Title: Transmit Center Frequency Tolerance for MR-FSK

Re: Task Group 15.4g LB59 comment resolution

Abstract: Comment resolutions related to MR-FSK PHY

CIDs: #186 # 687

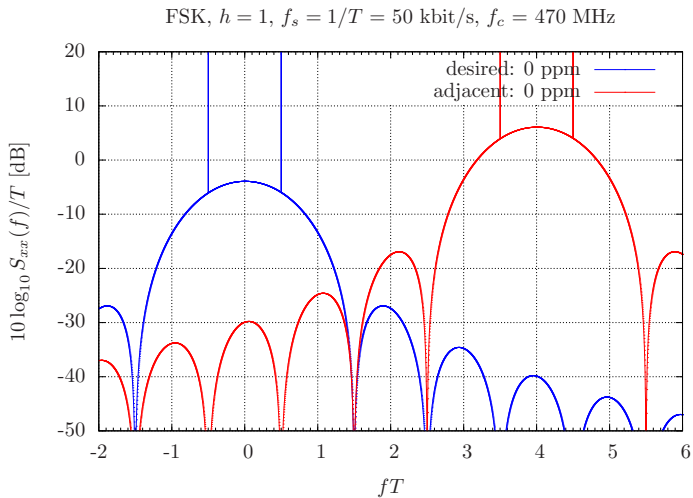
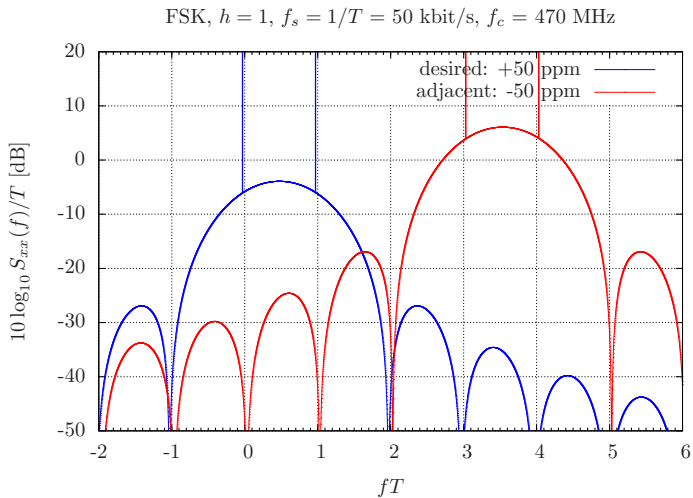
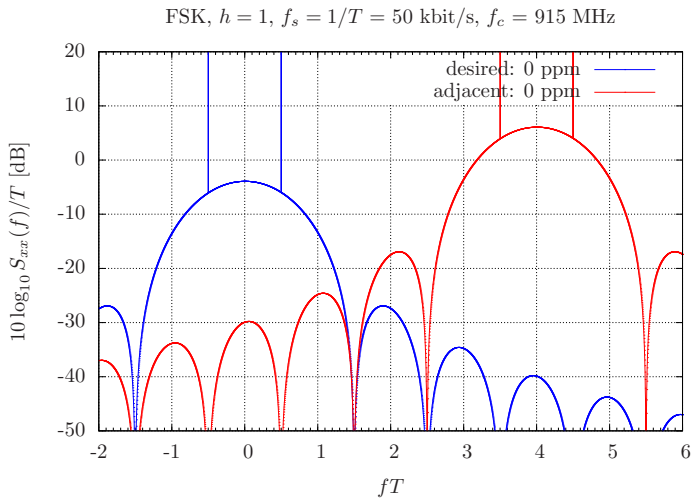
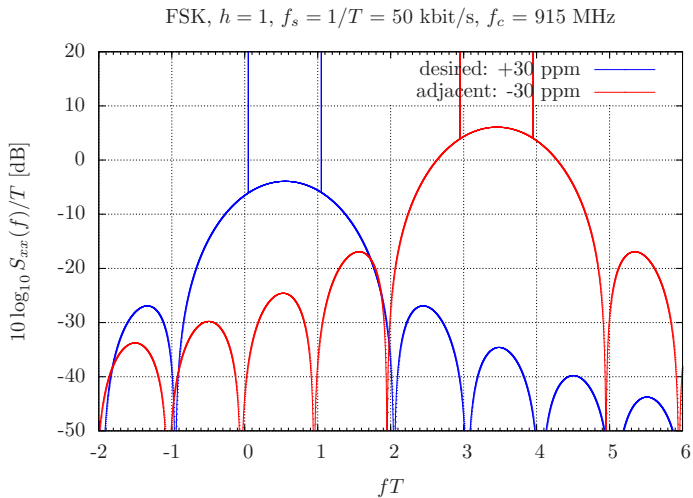
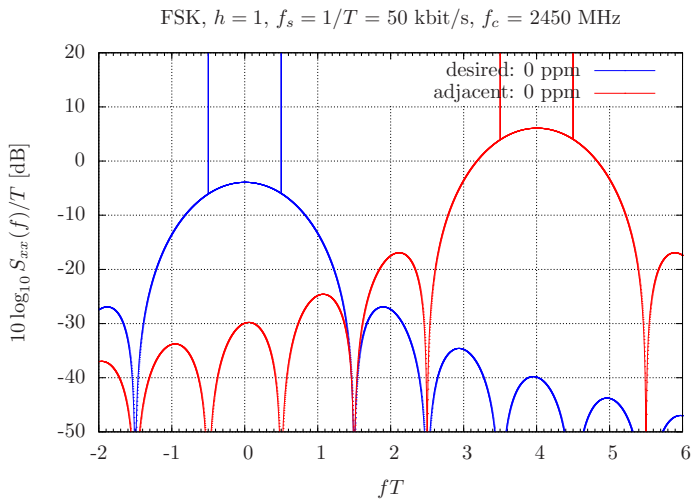
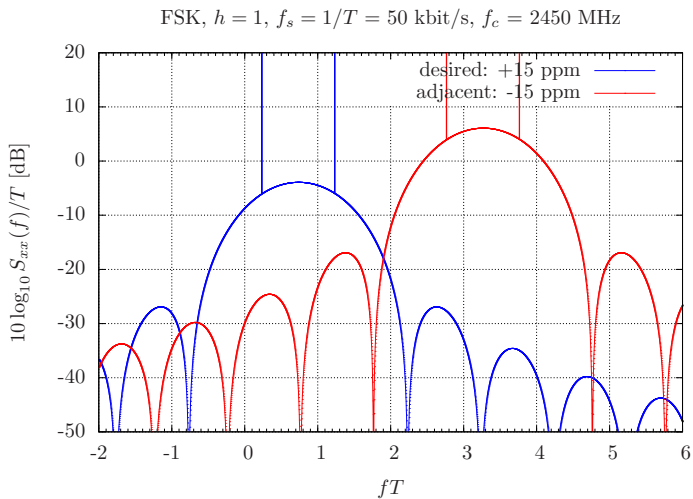
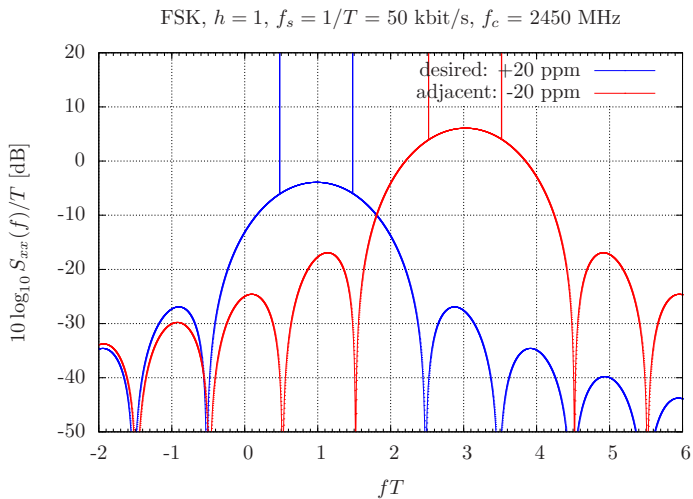
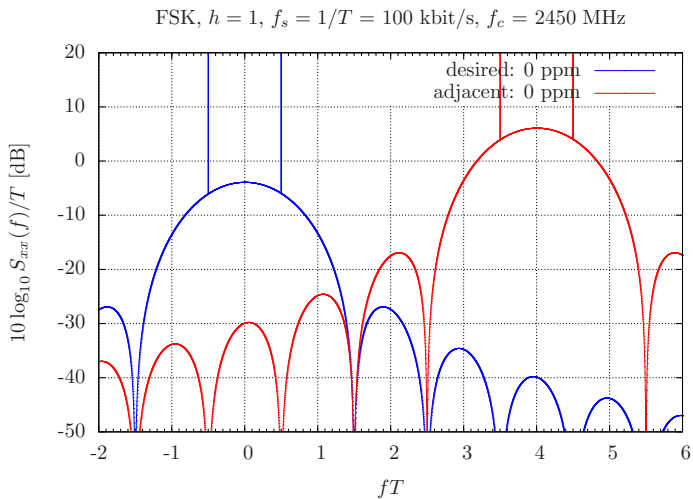
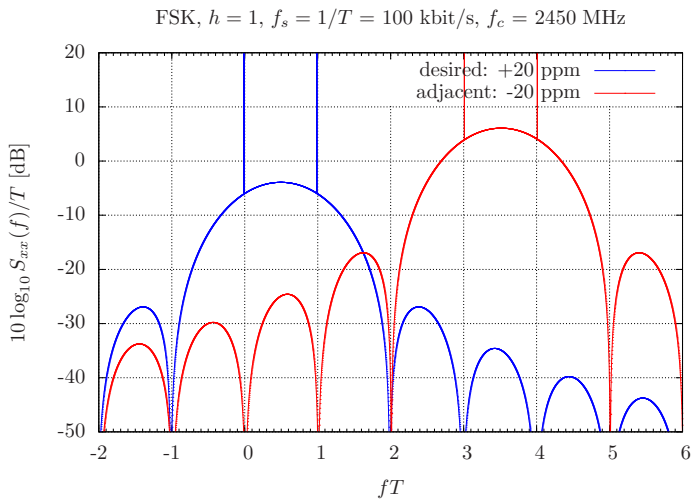
- ▶ The adjacent channel is located at $4/T$ offset from the desired channel.
- ▶ The power of the adjacent channel is 10 dB above the desired channel.
- ▶ Let ϵ be the frequency tolerance in ppm.
- ▶ The desired channel is shifted $+\epsilon$ ppm w.r.t. the carrier frequency $f_c^{desired}$.
- ▶ The adjacent channel is shifted $-\epsilon$ ppm w.r.t. the carrier frequency $f_c^{adjacent}$.

- ▶ At the 2400-2483.5 MHz band, the transmit center frequency tolerance is ± 15 ppm maximum for the mandatory mode (FSK, $f_s = 50$ kbit/s, $h = 1$).
- ▶ This does not harmonize with the specification of the MR-OFDM and MR-O-QPSK PHY (both PHYs tolerate up to ± 20 ppm).
- ▶ Compared to the tolerance of ± 40 ppm (IEEE-802.15.4-2006), even the required ± 20 ppm will add noticeable costs for test, calibration and board design.
- ▶ Hence, care should be taken with regard to the transmit center frequency tolerance.

- ▶ The MR-FSK PHY mandates at least 10 dB adjacent channel rejection.
- ▶ However:
 - ▶ The requirements on the spectral mask are quite relaxed.
 - ▶ There is no processing gain.
 - ▶ There is no coding gain for the mandatory modes.
 - ▶ There influence due to clock frequency tolerance is quite substantial.
- ▶ Though the specification are consistent with regard to the receiver jamming resistance (see section 6.12a.4.3, assuming an unmodulated carrier at a fixed offset), there will be moderate adjacent channel rejection in practical applications at 2400-2483.5 MHz.

frequency band (MHz)	channel spacing (kHz)	h	f_s (kbit/s)	max. Tol (ppm)
2400-2483.5	200 \rightarrow 400	1	50 \rightarrow 100	≈ 15 \rightarrow ≈ 20

frequency band (MHz)	channel spacing (kHz)	h	f_s (kbit/s)	max. Tol (ppm)
2400-2483.5	200 \rightarrow 400	0.5	50 \rightarrow 150	≈ 15 \rightarrow ≈ 20

frequency band (MHz)	channel spacing (kHz)	h	f_s (kbit/s)	max. Tol (ppm)
2400-2483.5	200 \rightarrow 400	1	50	≈ 15 $\rightarrow \approx 20$

frequency band (MHz)	channel spacing (kHz)	h	f_s (kbit/s)	max. Tol (ppm)
2400-2483.5	200	1	50	≈ 15 $\rightarrow \approx 20$
